Access Compliance Report

Public Rights-of-Way

(Curb Ramps)

Intersection ID: 20640	Main Street: S_TRYON_ST	Cross Street: YAGER_CREEK_DR	Location: N
ADA ID: F8BD30C637F9	Ramp Type: Para	Initial Pass/Fail: Fail	Overall Compliance: No
Severity Score: 25			
Codes/Mitigation Info/Possible Solution		Field Measurements/Component Compliance

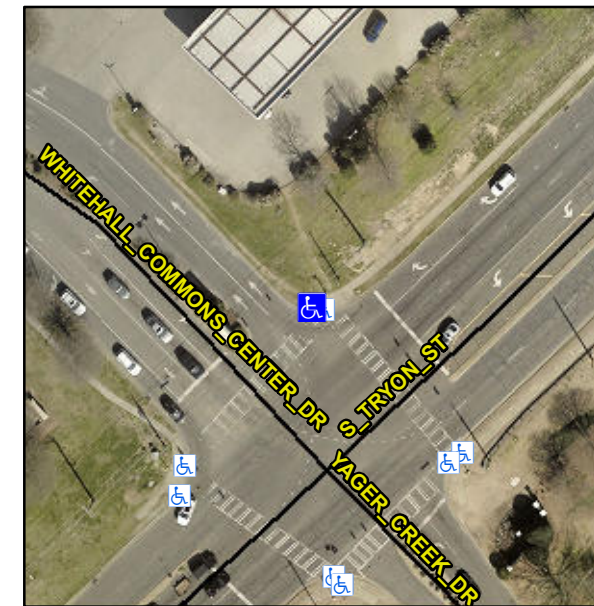
Surveyor Notes:

RT RP < 5%

PROW/ADA:

R304.3.2, R304.5.3

Possible Solutions:

**Remove & Replace Entire Ramp.
Restripe Crosswalk.**
